## Memorandum

**Re:** Interstate 80/Gilman Street Interchange Improvement Project  
– Addendum to the Technical Reports  
District 04 - ALA - 80 - PostMiles 6.38 / 6.95  
EA 04-0A7700 / Project ID# 0400020155

### 1.1 ADDENDUM OF FIGURE REVISIONS

Figure 2. Project Location Map

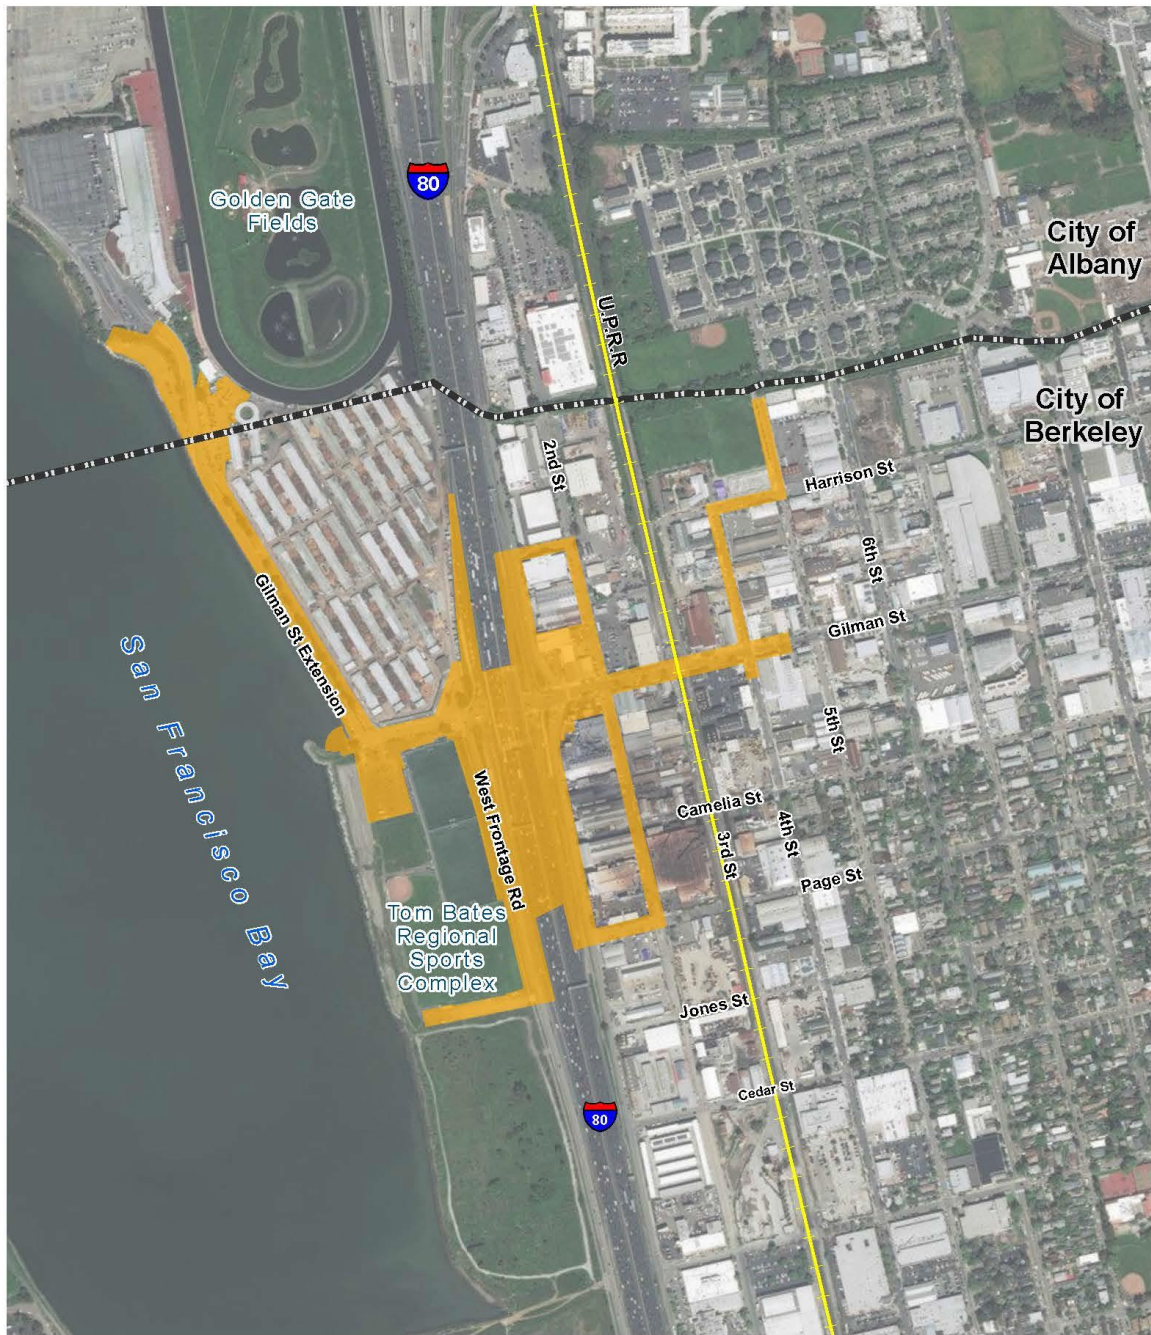
This addendum updates the project footprint and study area boundary depicted in various figures in the technical reports prepared for the Interstate 80 (I-80)/Gilman Street Interchange Improvement Project. This revision to the project footprint and study area boundary does not result in any change in the affected environment or potential impacts, and the findings presented in the previously approved technical reports remain valid. The technical reports, figure number, and figure name included in this addendum are identified below. The revised figures are attached at the end of this memorandum.

Figure 2. Project Location Map

Appendix A Figure 1

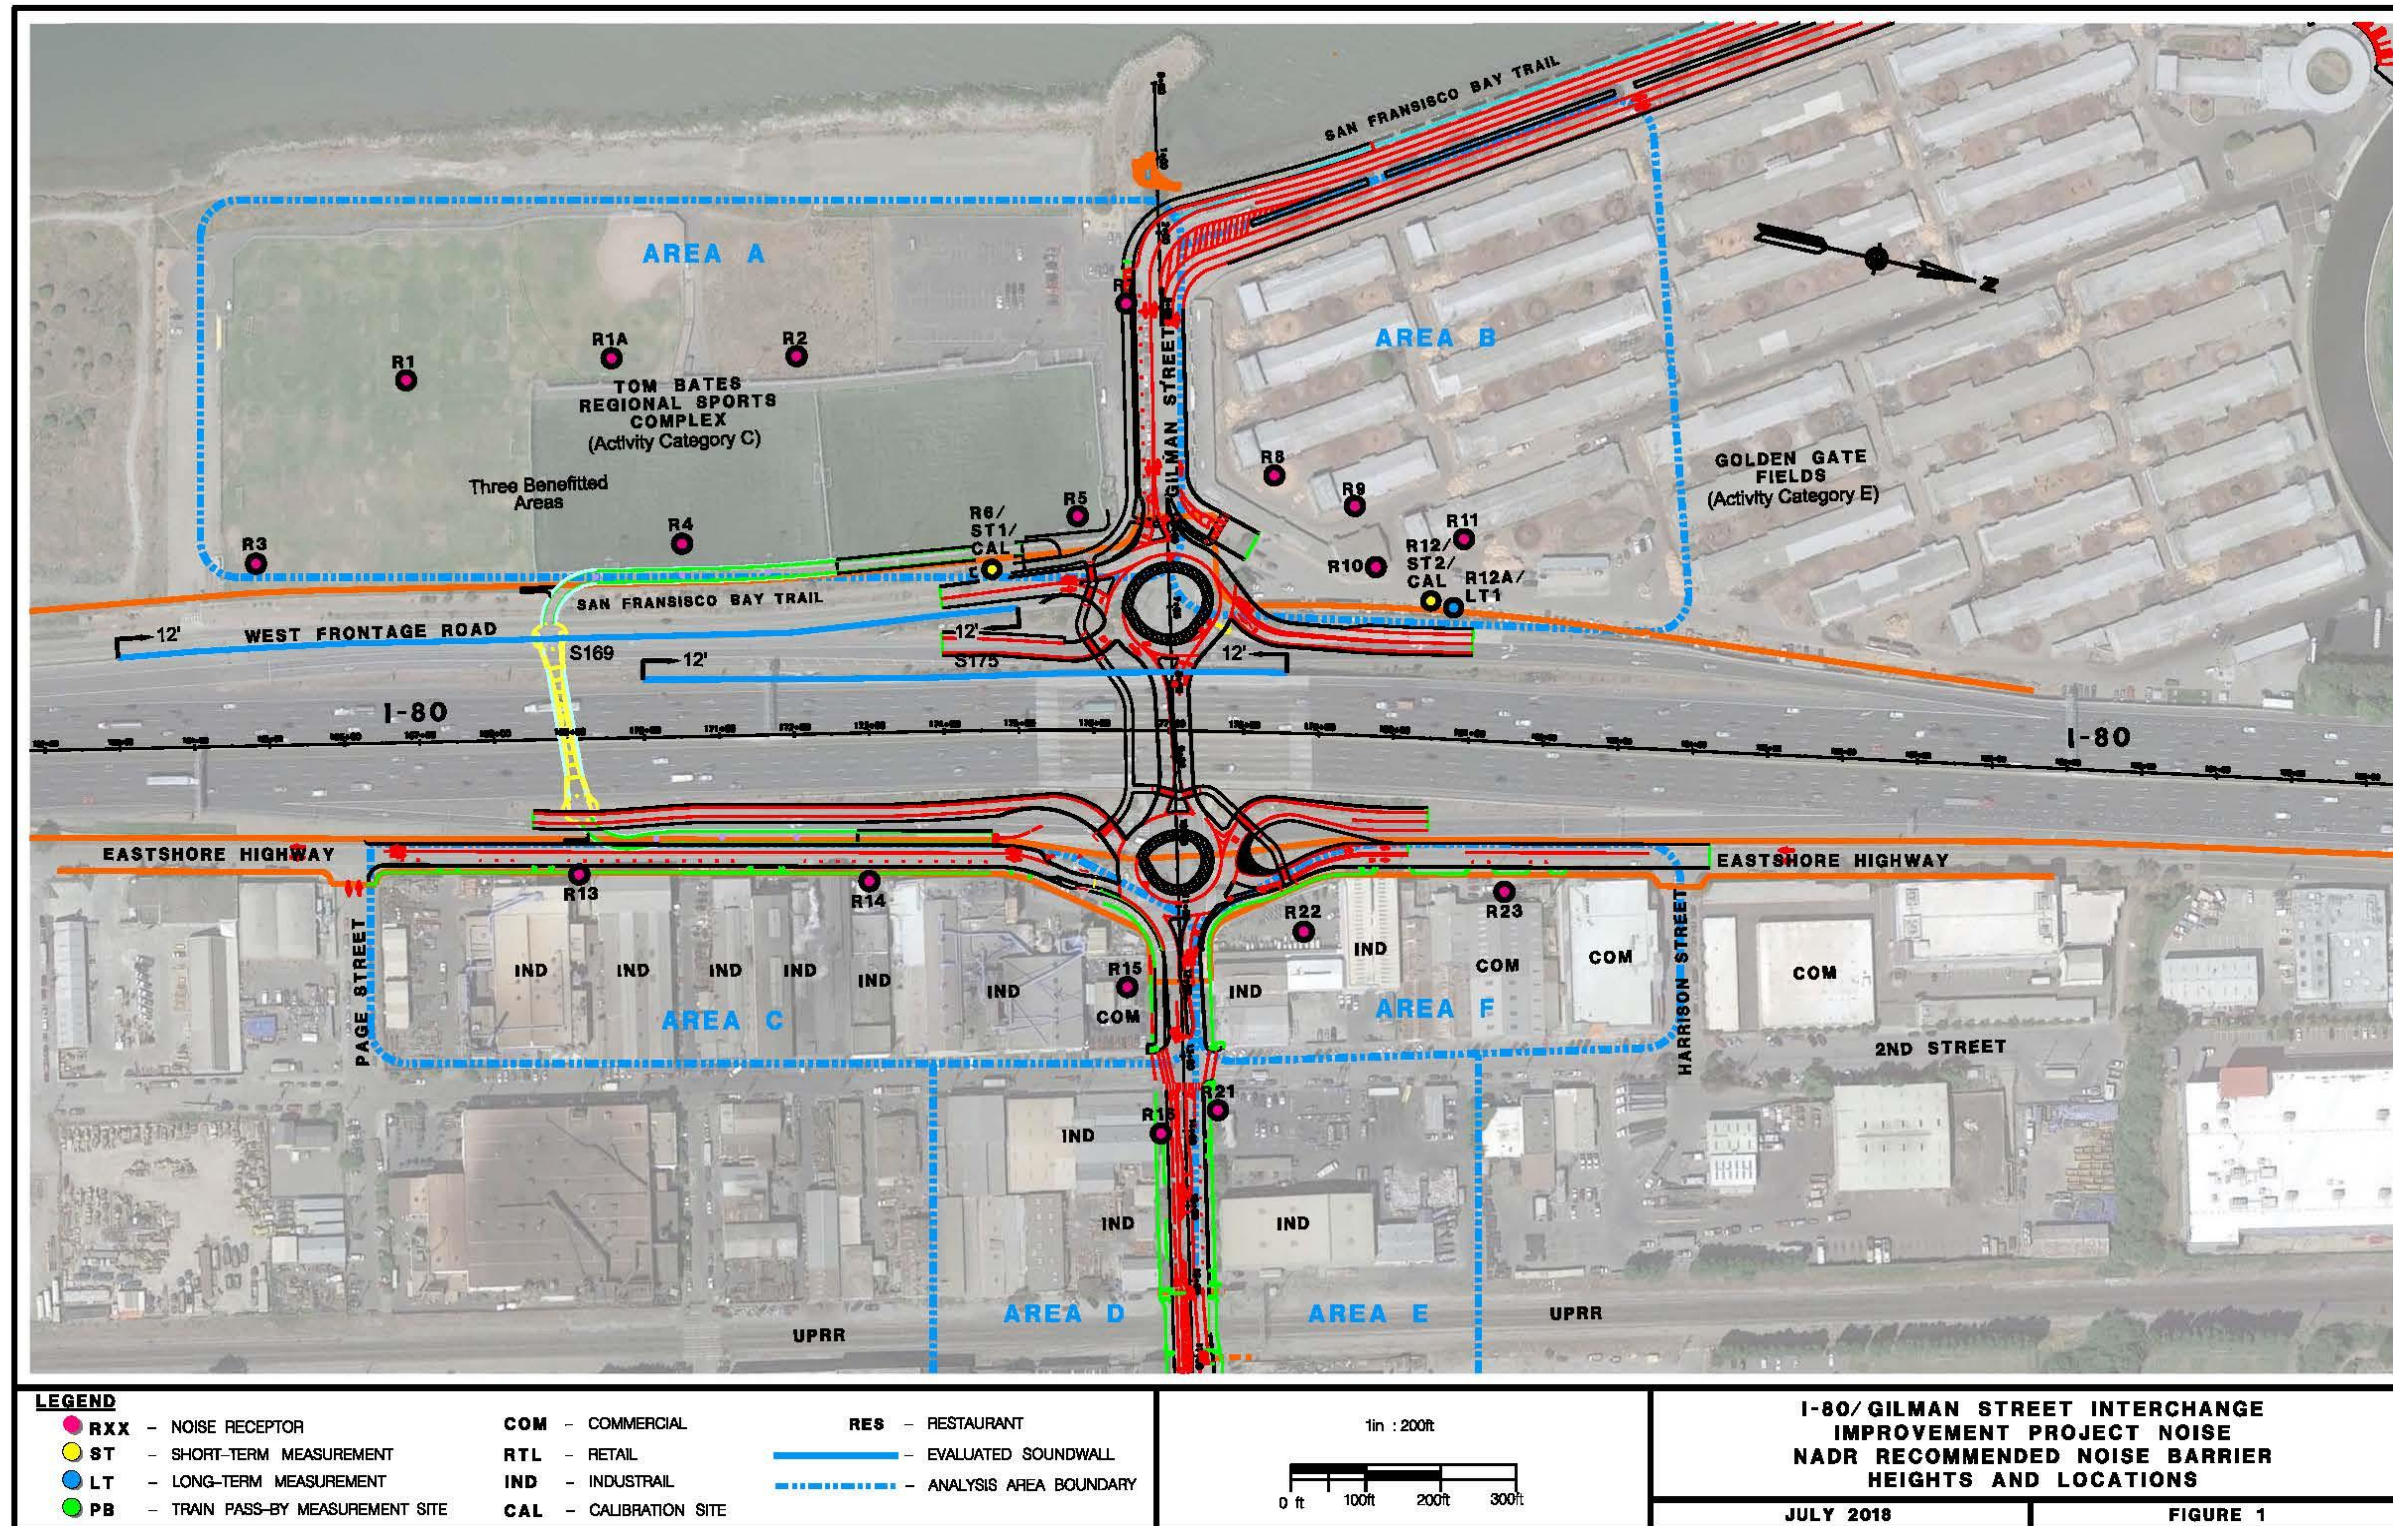
Appendix A Figure 1

Figure 2-2. Project Location Map

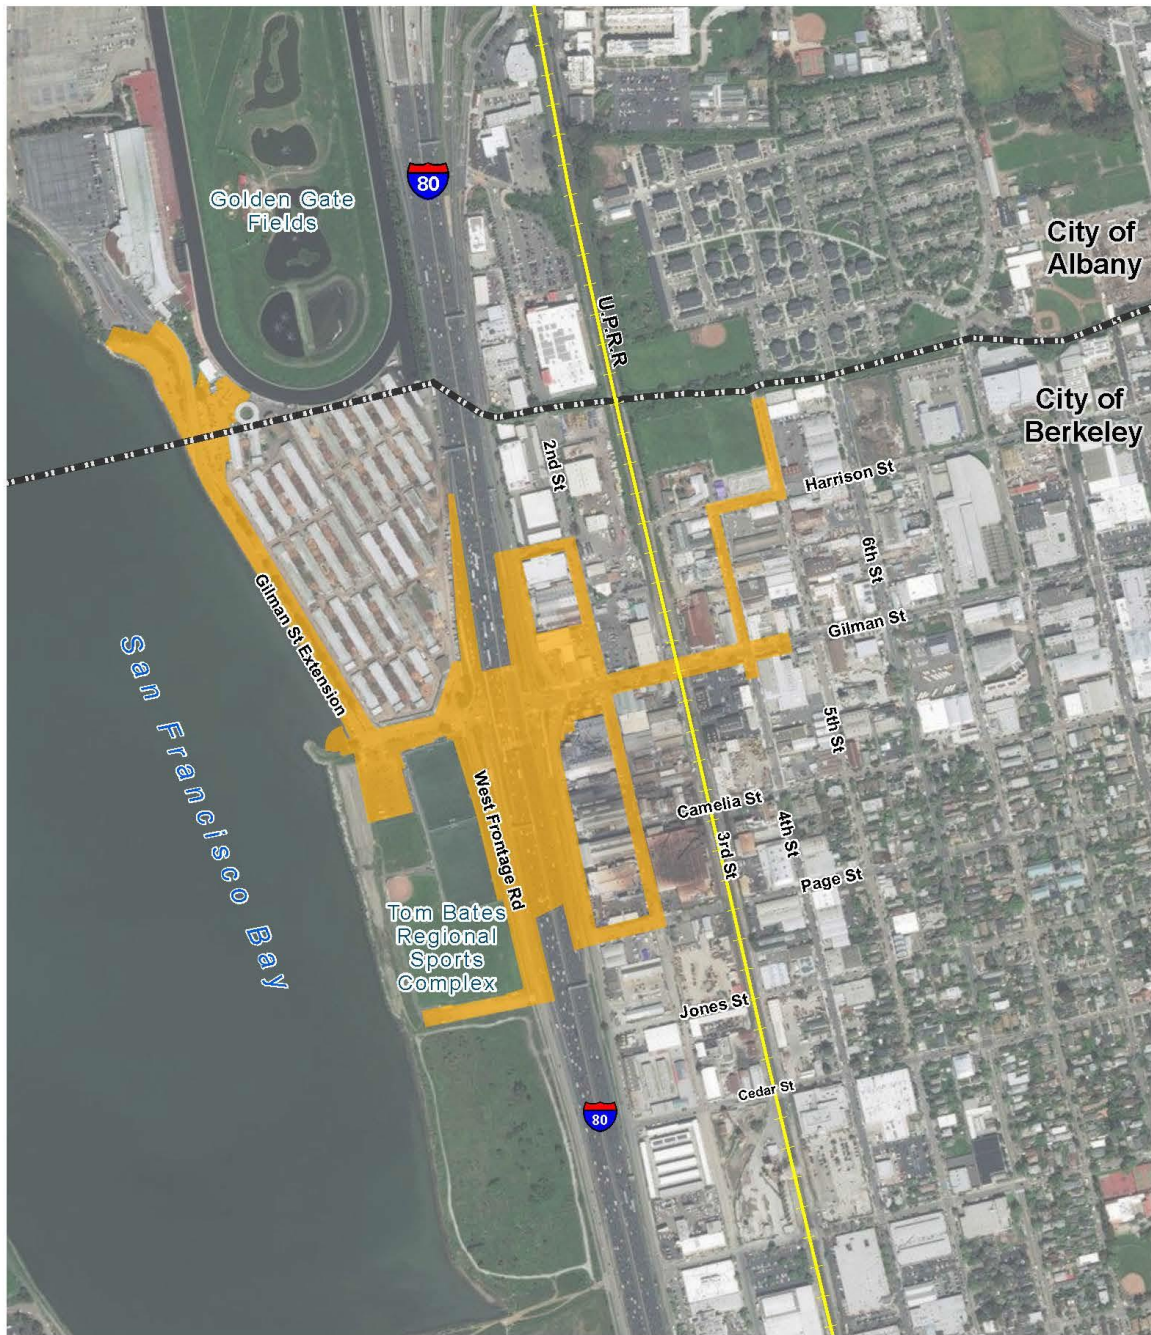
Figure 2-2. Project Location Map

Appendix A Figure 1

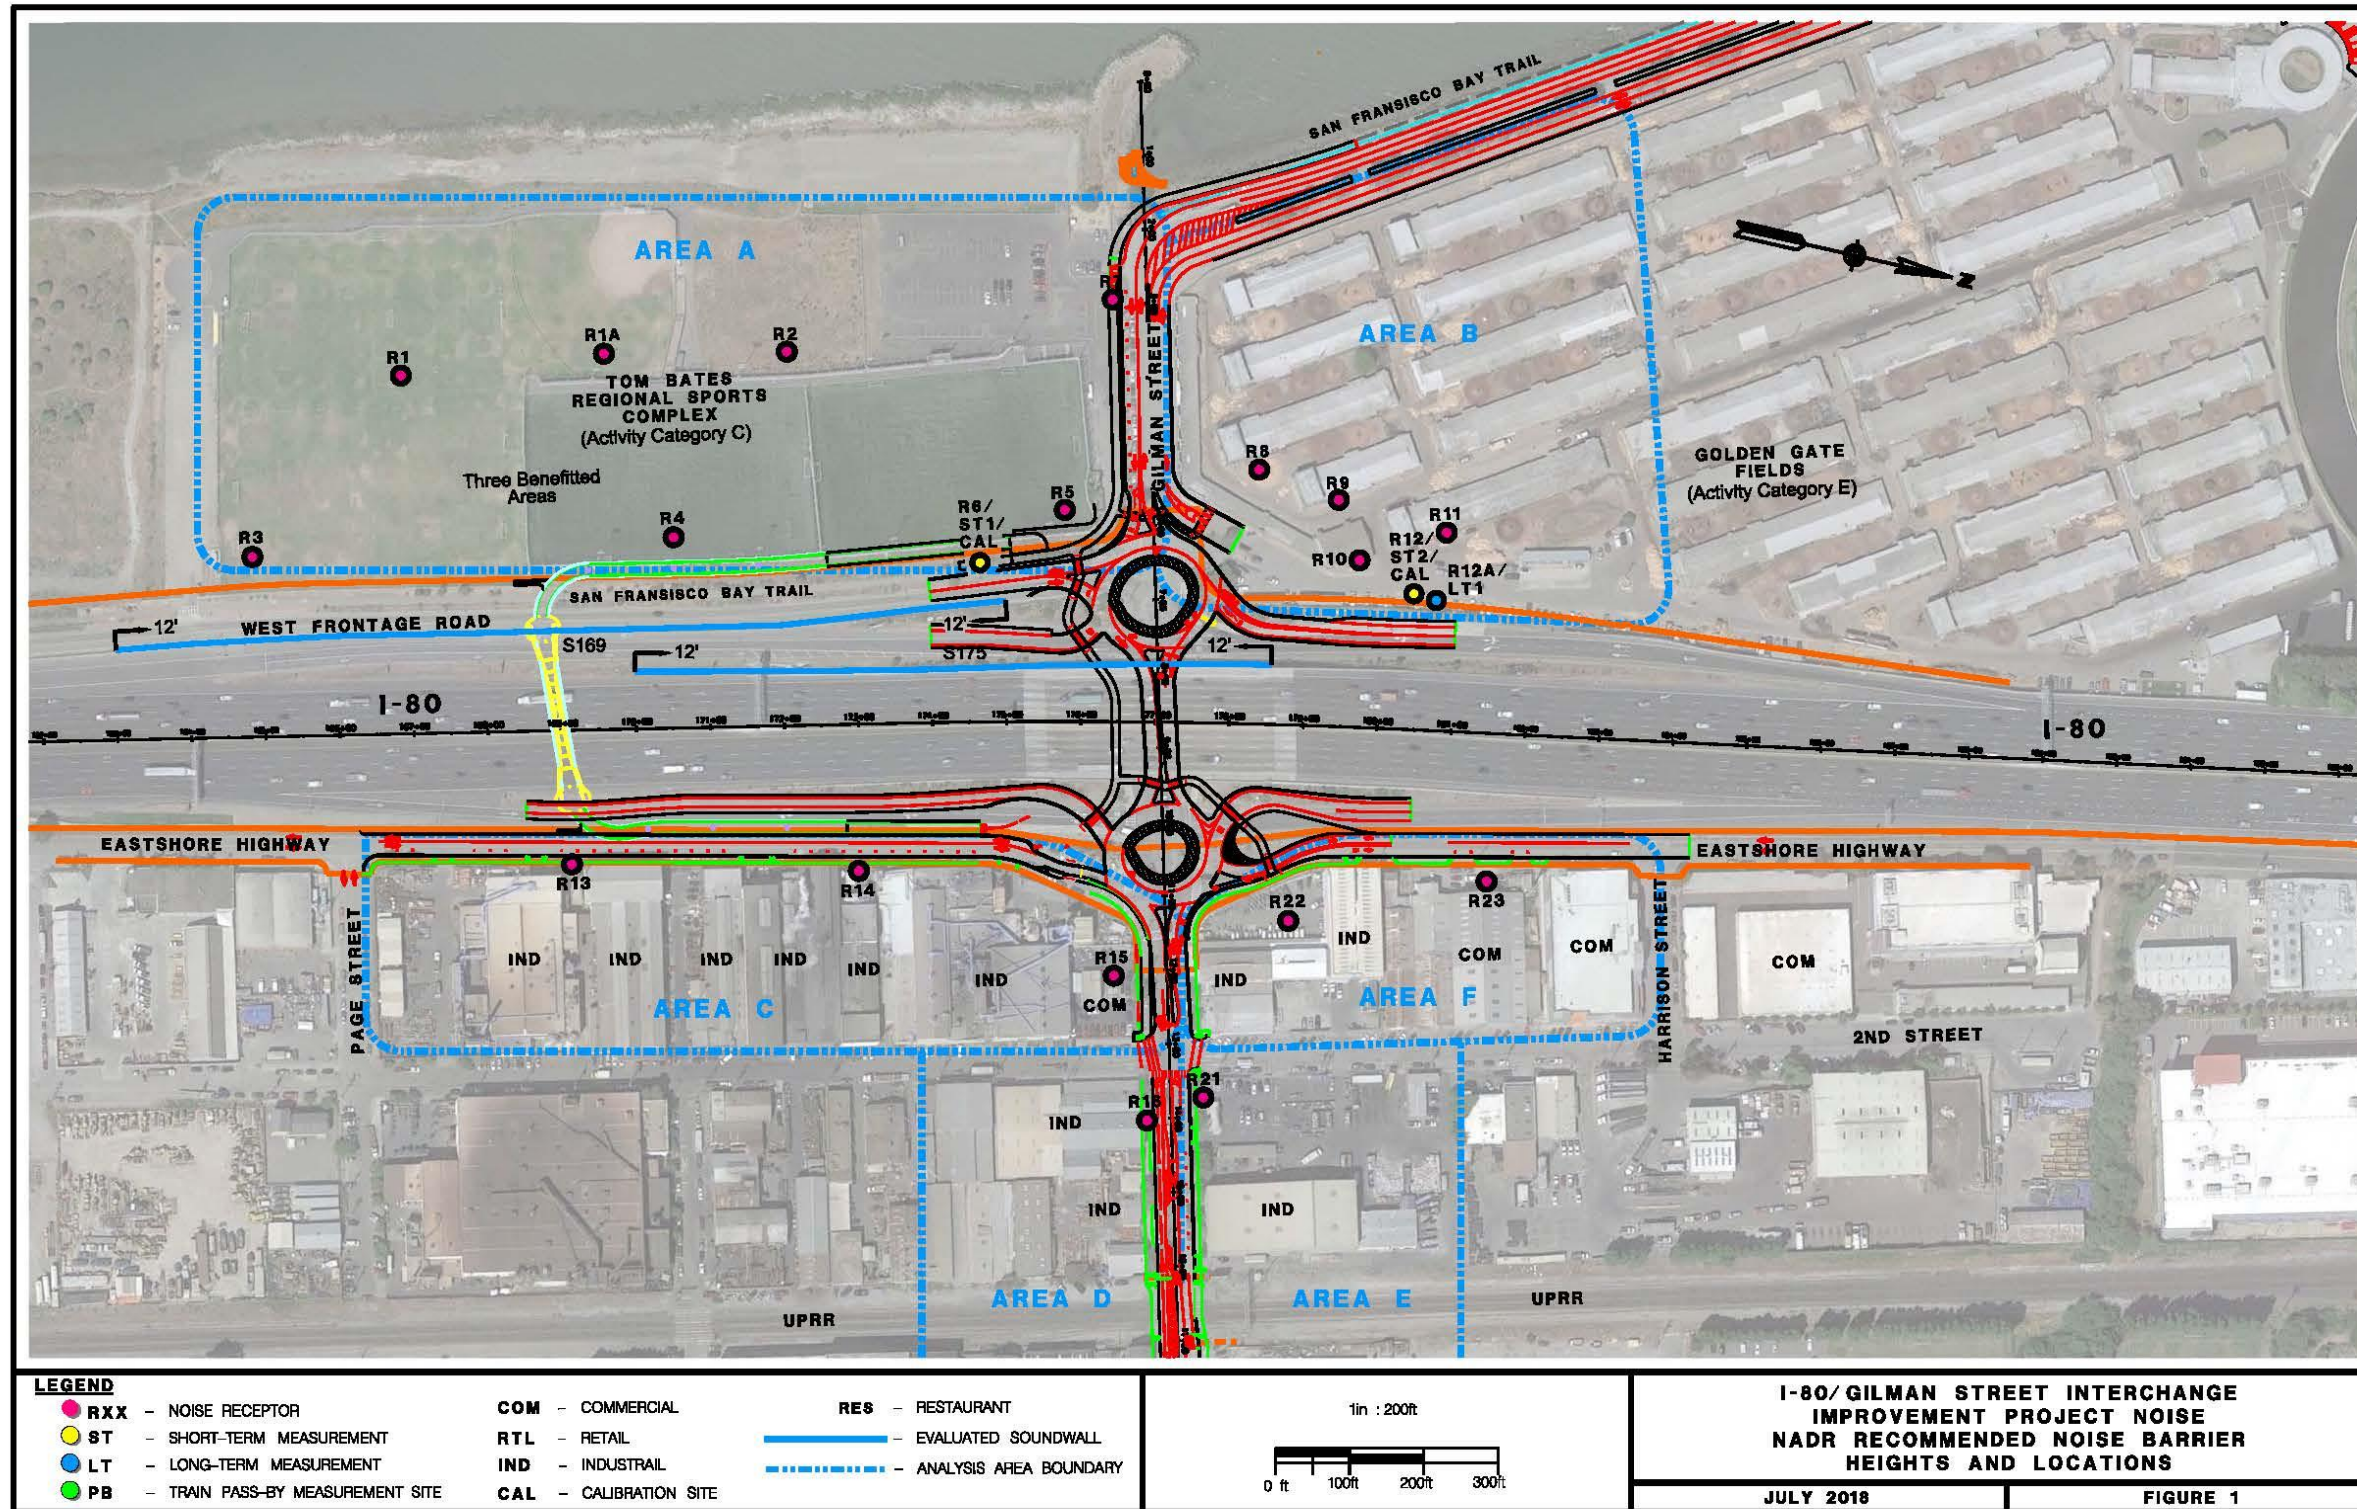
Appendix A Figure 1
